**Appendix D- Elephant & Castle to Crystal Palace Quietway (QW7)  
Calton Avenue to Farquhar Road**

**Section 3  
Responses to Consultation Questions**

**Amended Proposals**

Amendments to Parking (figures excludes parking discouraged at junctions by introduction of double yellow lines)

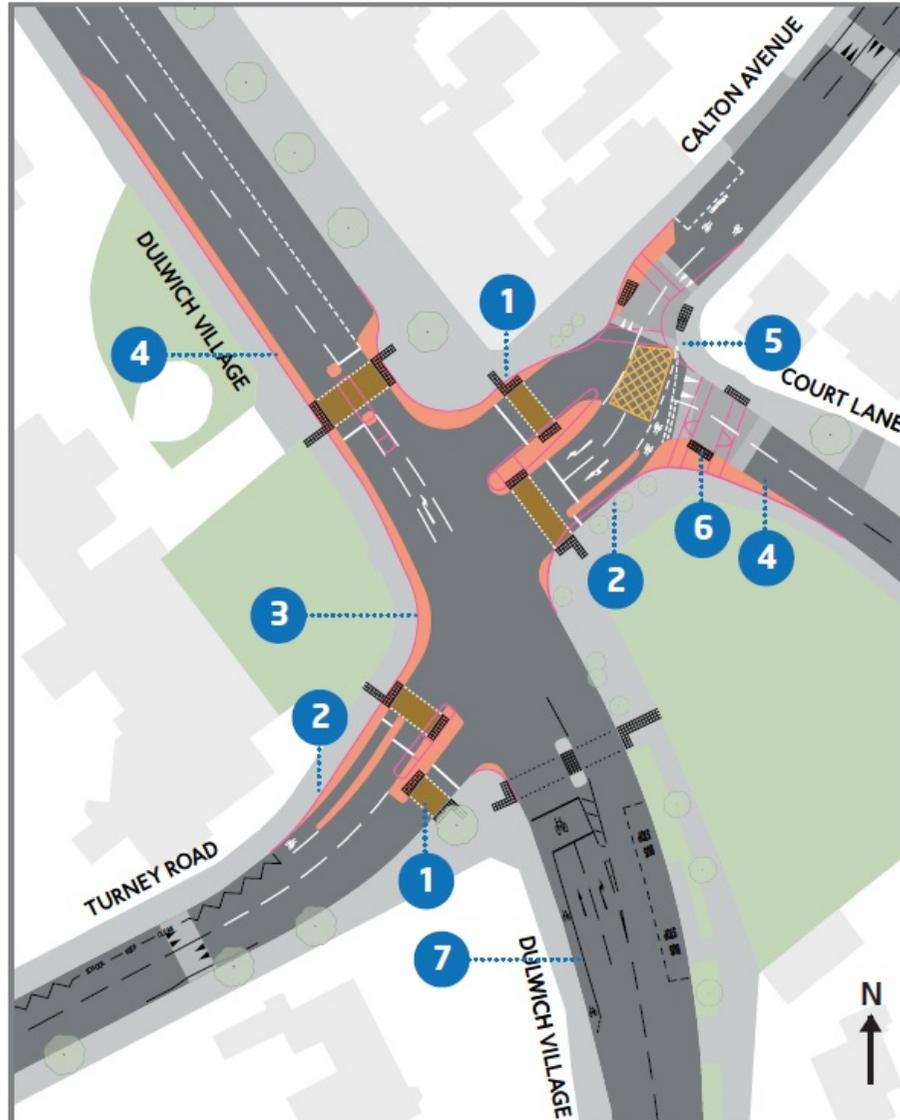
<b>Calton Avenue / Court Lane</b>				
<b>Reference No on consultation Map</b>	<b>Feature proposed during consultation</b>	<b>What you said</b>	<b>Proposed Changes / Action / Amendments</b>	<b>Reasons</b>
2	Parking restrictions at junctions	Concerned about loss of parking, although this had majority support	Review and reduce extent of yellow lines to the minimum required for safety and ease of access to signal junction	<ul style="list-style-type: none"> <li>Yellow lines at junctions will improve safety for all road users</li> <li>Standard borough wide practice</li> </ul>
3	Parking restrictions on Court Lane	Concerned about loss of parking, although this had majority support	Review and reduce extent of yellow lines to the minimum required for safety and ease of access to signal junction	<ul style="list-style-type: none"> <li>Yellow lines on Court Lane will remove pinch point by parked cars and improve ease of access to the signal junction</li> </ul>

4	Parking restrictions on Calton Ave SW of Gilkes Crescent	Concerned about loss of parking. This lack majority support	Review and reduce extent of yellow lines to the minimum required for safety and ease of access to the signal junction	<ul style="list-style-type: none"> <li>Yellow lines will improve safety for pupils crossing Calton Avenue, with the aid of school crossing patrol</li> <li>Yellow lines will improve access to the signal junction</li> <li>A new loading bay provided adjacent to shops on Calton Avenue</li> <li>Car club bay relocated to Gilkes Crescent</li> </ul>
5	New zebra crossing	You feel this at the wrong location. This lack majority support.	Relocate zebra on Calton Avenue to the east of Woodward Road	<ul style="list-style-type: none"> <li>Relocated zebra will be at the best location where most pupils cross the road</li> <li>Safer location.</li> </ul>
6	Provision of marked parking bays	Concerned about the loss of parking. This lack majority support.	Feature dropped	Not well supported

7	Removal of centre line	Concerned that this will reduce safety. This lack majority	Feature dropped on Calton Avenue	<ul style="list-style-type: none"> <li>The road is not intended to be resurfaced, thus</li> </ul>

Calton Avenue / Court Lane Parking Amendments (subject to safety audit )-Number of spaces		
	Net gain -	Net loss
<b>Previously Proposed</b>		13
<b>Now amended</b>	No Net change.

Dulwich Village Junction map

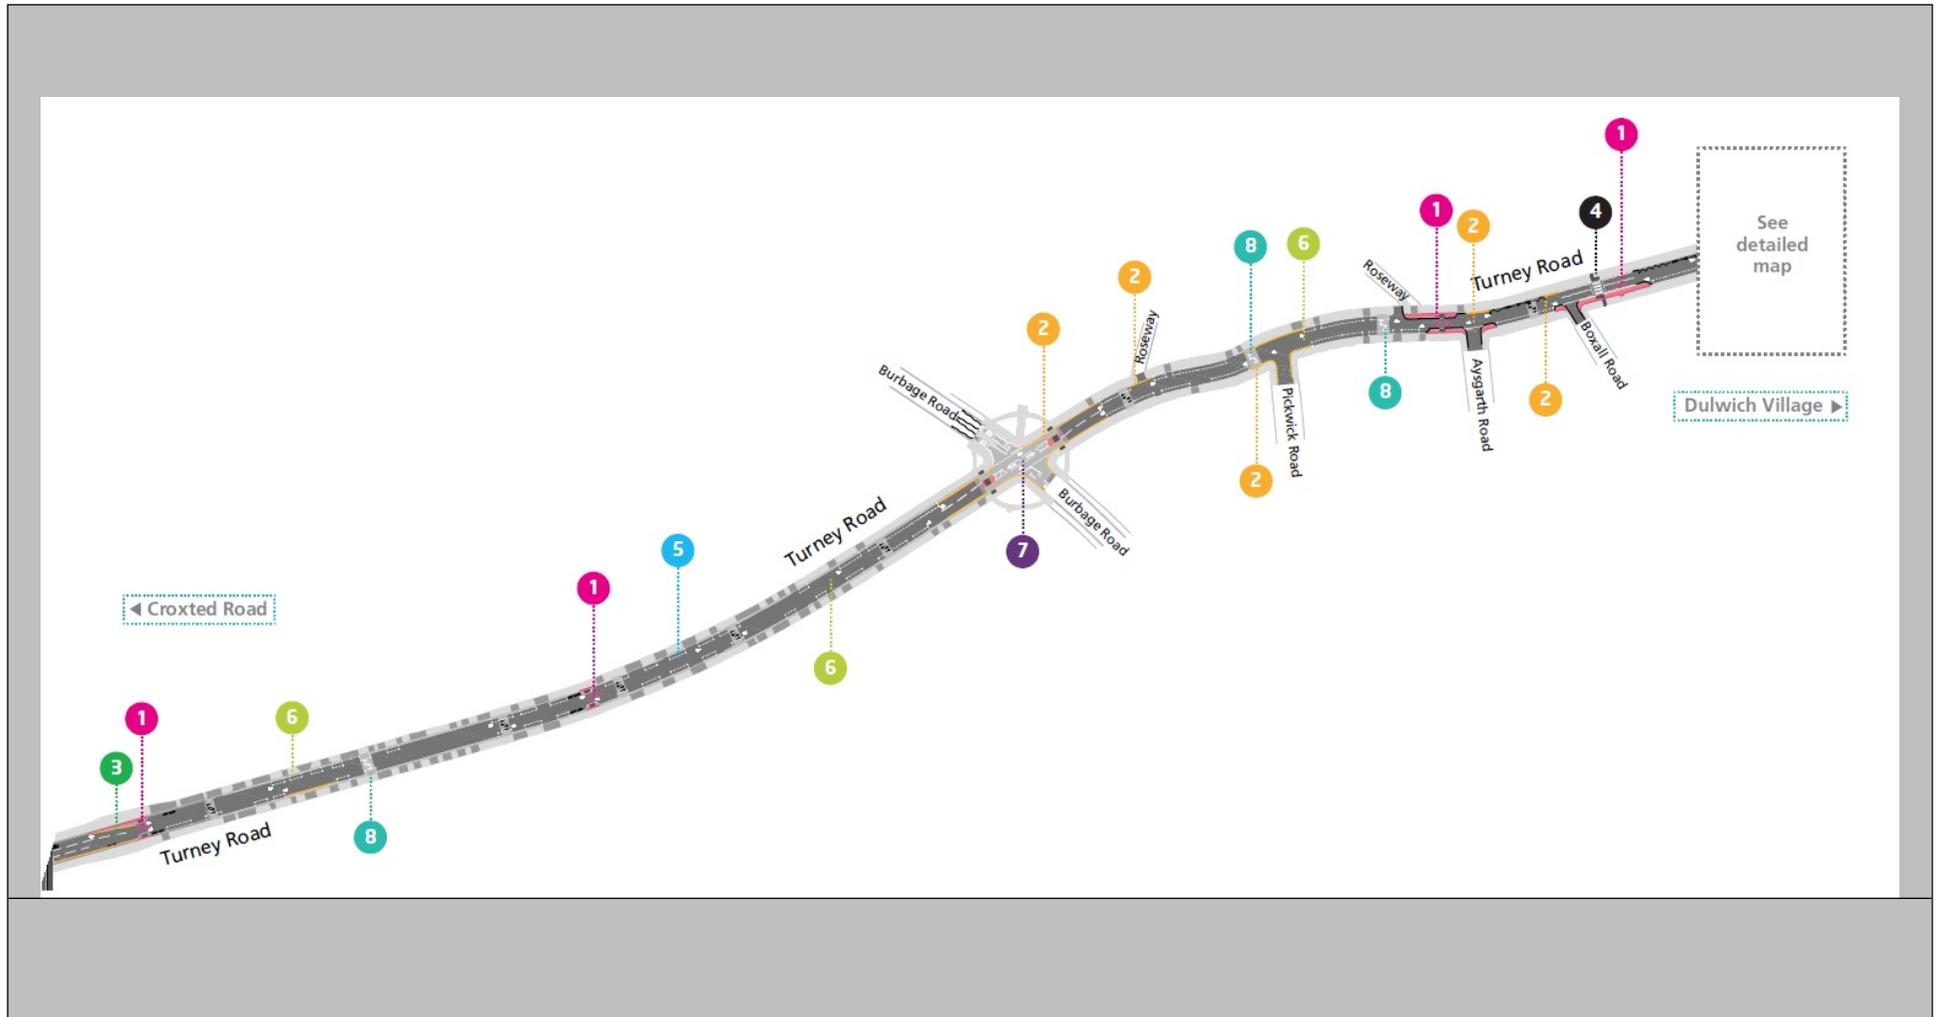
<b>Dulwich Village junction</b>				
<b>Reference No on consultation Map</b>	<b>Feature proposed during consultation</b>	<b>What you said</b>	<b>Proposed Changes / Action / Amendments</b>	<b>Reasons</b>
7	Banned left turn from Dulwich Village northbound	This will cause rat-running in the local area. This lack majority support	Drop proposal subject to detailed design and monitoring post-implementation	<ul style="list-style-type: none"> <li>Ban preferred to accommodate wider pedestrian refuge island on Turney Road.</li> <li>Currently very low flows making this turn in the peak hours (9 veh/hr am, 18veh/hr pm)</li> <li></li> </ul>
6	Court Lane junction layout	Concerned about traffic delays, possible increase in congestion and traffic displacement to adjacent roads. This lack majority support	<ul style="list-style-type: none"> <li>Trial change in priority in temporary materials and reverse change in priority if delays are unacceptable on Court Lane</li> </ul>	<ul style="list-style-type: none"> <li>Proposed layout on Court lane allows segregated cycle lane at the signal junction.</li> <li>Discourage rat running on Court lane</li> <li></li> </ul>

5	Calton Ave / Court Lane change of priority	Concerned about traffic delays, possible increase in congestion and traffic displacement to adjacent roads. Concerned about impact on pupils crossing Calton Avenue with the aid of school crossing patrol This lack majority support	<ul style="list-style-type: none"> <li>Trial change in priority</li> <li>Introduce additional measures to reinforce informal pedestrian crossing on Court lane and Calton Avenue.</li> </ul>	<ul style="list-style-type: none"> <li>The proposed layout will improve safety all road users</li> </ul>
4	Footway widening	Concerned this will increase congestion due to reduction in roads space. This lack majority support	<ul style="list-style-type: none"> <li>Proceed as proposed due to safety benefits for pupils</li> </ul>	<ul style="list-style-type: none"> <li>Footway widening on Dulwich Village will not affect traffic lane</li> <li>Will improve safety for pupils .Pedestrian comfort level assessment indicate congestion at areas where footway widening is proposed-<i>refer to Dulwich Village report</i></li> </ul>

3	Guardrail removal	Concerned about safety for	Undertake independent safety review	<ul style="list-style-type: none"> <li>Some level of</li> </ul>

pupils . This lack majority support	to access extent of removal. Some railings can be retained	<p>guardrail required to prevent pupils from 'spilling' onto the street</p> <ul style="list-style-type: none"> <li>• Unnecessary guardrail may affect footway width at congested areas</li> </ul>
2	Provision of segregated cycle facility	Concerned about conflicts between cyclist and pedestrian at internal stop lines. This lack majority support	<ul style="list-style-type: none"> <li>• Careful monitoring of the compliance of internal stop lines will be undertaken and enforcement carried out if needed eg road signs</li> <li>•</li> </ul>	<ul style="list-style-type: none"> <li>• Segregating cyclists in space and time will improve safety for all road users</li> <li>• Internal stop lines necessary to ensure delays are reduced at the junction</li> </ul>
1	Staggered Crossings	Concerned about: <ul style="list-style-type: none"> <li>• The capacity of island to accommodate volume of pedestrian waiting.</li> <li>• Safety of pupils not waiting</li> </ul> This lack majority support	<ul style="list-style-type: none"> <li>• Undertake pedestrian comfort level assessment of the proposed island.</li> <li>• Review scope for widening island to provide more capacity for waiting pedestrians.</li> <li>• Introduce pedestrian count down to improve safety</li> </ul>	<ul style="list-style-type: none"> <li>• Island will have high kerbs to act as guardrails to restrain pedestrians. Similar to that at Herne Hill</li> <li>• Waiting time reduced for pedestrians (82sec / 72sec vs. 77sec / 69sec)</li> <li>• More green time given to pedestrians :(Turney Road-13sec increased to 65sec /66sec, Calton Avenue-6sec increased to 52sec / 53sec</li> <li>• Improved crossing points further down Turney Road will reduce pressure on this arm of the junction</li> </ul>

<b>Turney Road</b>

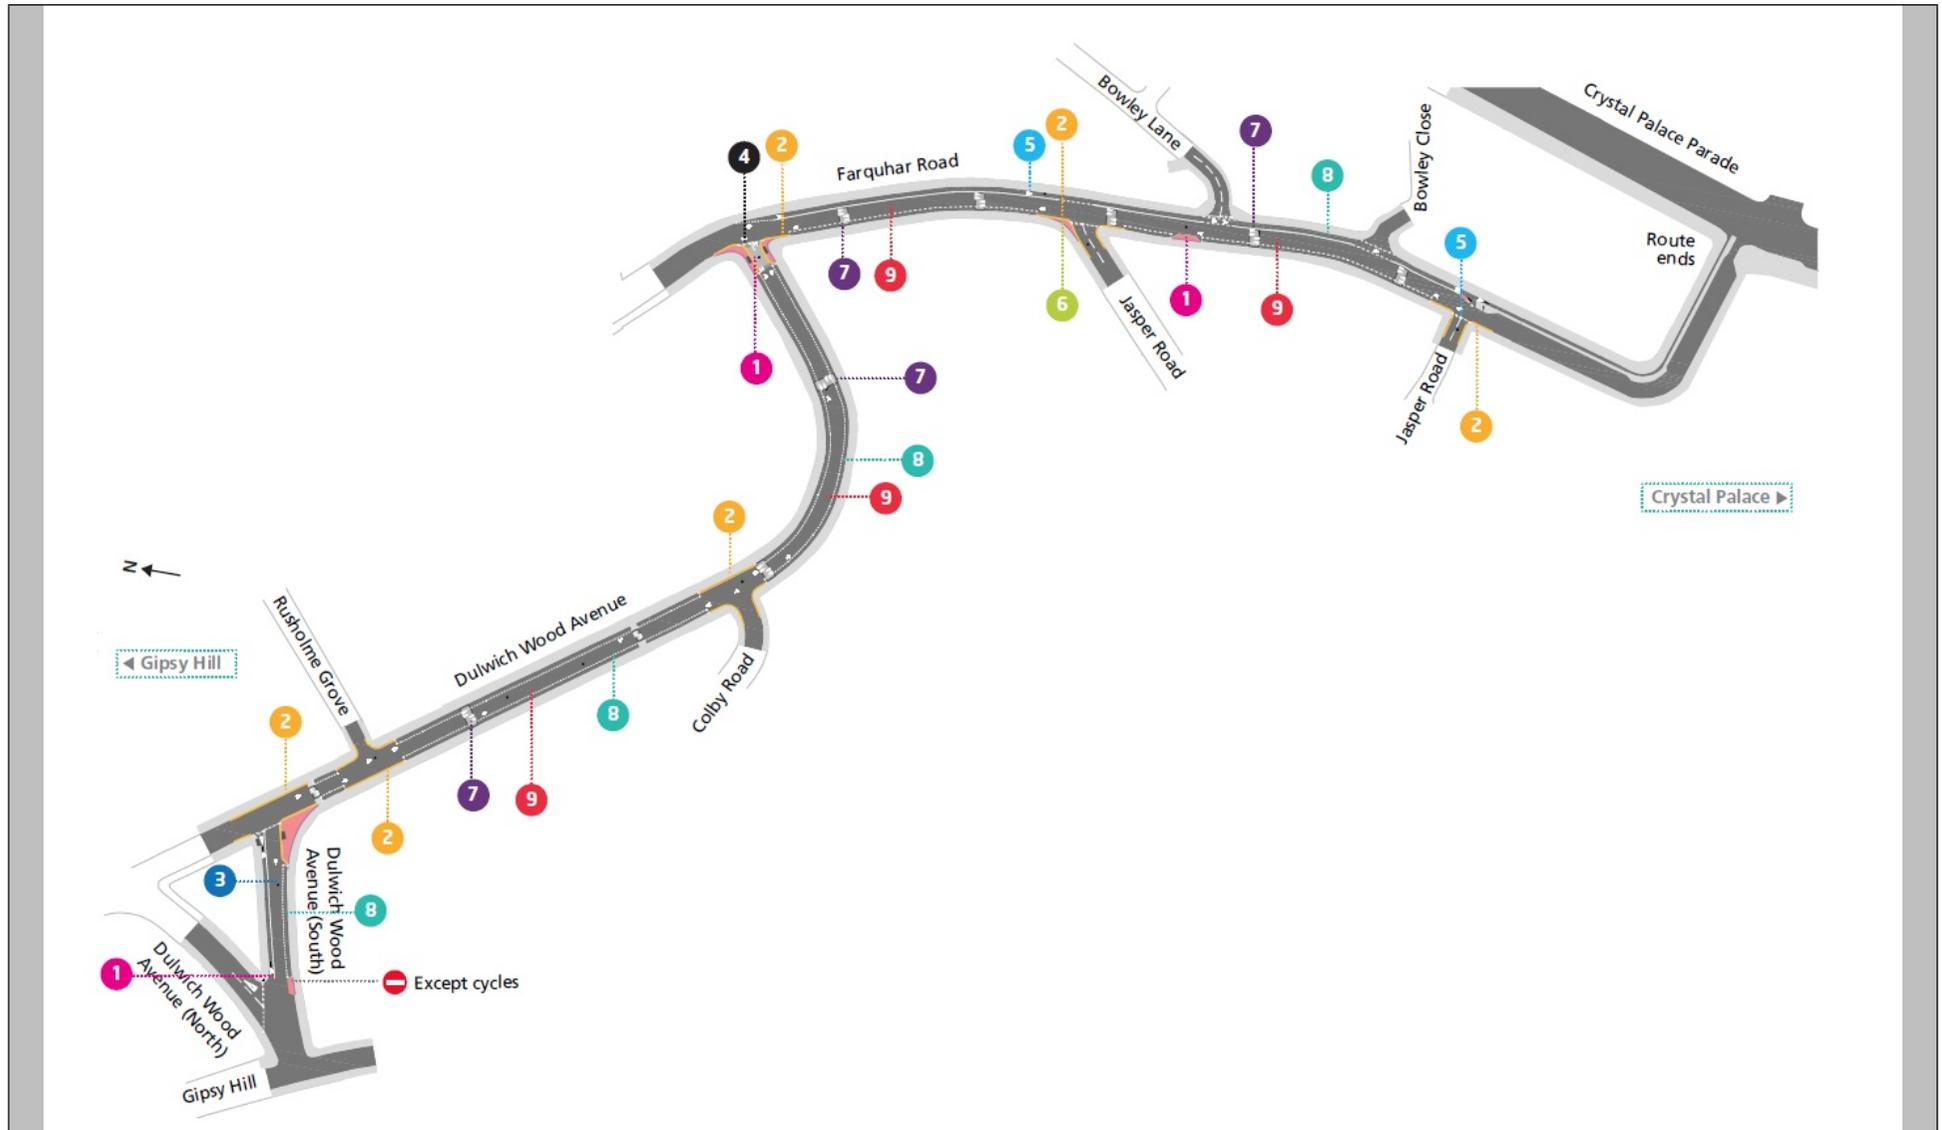
<b>Turney Road</b>				
<b>Turney Road</b>				
<b>Reference No on consultation Map</b>	<b>Feature proposed during consultation</b>	<b>What you said</b>	<b>Proposed Changes / Action / Amendments</b>	<b>Reasons</b>
2	Parking restrictions at junctions	Concerned about loss of parking, although this had majority support	Review and reduce extent of yellow lines to the minimum required for safety.	<ul style="list-style-type: none"> <li>Yellow lines at junctions will improve safety for all road users</li> <li></li> </ul>
3	Parking restrictions at Croxted Road	Concerned about loss of parking, although this had majority support	<ul style="list-style-type: none"> <li>Retain as proposed</li> </ul>	<ul style="list-style-type: none"> <li>Yellow lines discourage parking under the bridge which creates pinch point</li> </ul>
4	New zebra crossing	Well supported	<ul style="list-style-type: none"> <li>Retain as proposed</li> </ul>	<ul style="list-style-type: none"> <li>Will improve safety for pupils</li> </ul>

5	Provision of marked parking bays	Concerned about the loss of parking. This lack majority support.	Feature dropped	Not well supported
6	Removal of centre line	Concerned that this will reduce safety. This lack majority support.	Feature dropped	<ul style="list-style-type: none"> <li>Statistical Research shows that removing centre line marking significantly reduces vehicle speeds- <a href="http://content.tfl.gov.uk/centre-line-removal-trial.pdf">http://content.tfl.gov.uk/centre-line-removal-trial.pdf</a></li> </ul>
2	Burbage Road pedestrian improvements	Supported	<ul style="list-style-type: none"> <li>Retain as proposed</li> </ul>	<ul style="list-style-type: none"> <li>Will improve safety for pupils</li> </ul>
8	Additional traffic calming	You felt this was unnecessary and will make it uncomfortable for road users. This lack majority support.	<ul style="list-style-type: none"> <li>Retain as proposed</li> </ul>	<ul style="list-style-type: none"> <li>Spacing of existing humps are inconsistent, some over 100m apart</li> <li>3 new humps will ensure consistent steady speed , necessary to enforce 20mph</li> </ul>

1	Replacing traffic island with footway buildout	Concerned buildout will reduce road width and motorists unable to overtake cyclists. You feel traffic islands are safer This lack majority support	<ul style="list-style-type: none"> <li>• Retain as proposed</li> <li>• Detailed design to consider if can be raised to improve pedestrian convenience/safety</li> </ul>	<p>Most of the existing island are not designed for pedestrians and unsafe as a refuge :</p> <ul style="list-style-type: none"> <li>• width &lt; 1.5m,</li> <li>• No kerb protection.</li> <li>• Some islands adjacent driveways</li> <li>• No tactile paving</li> <li>• Unsafe for disabled / visually impaired users</li> <li>• Adjacent parked cars obscures visibility</li> </ul> <p>Islands can't be made wider due to adverse impact on traffic lane (&lt;3.0m).</p> <p><b>Footway buildout :</b></p> <ul style="list-style-type: none"> <li>• Buildout will not extend beyond parked cars</li> <li>• improves visibility for pedestrians</li> <li>• buildouts at junction encourage speed reduction and help to move the give-way lines forward to improve visibility</li> </ul>

Turney Road Parking Amendments (subject to safety audit )-Number of spaces		
	Net gain -	Net loss
<b>Previously Proposed</b>		20
<b>Now amended</b>	.	14
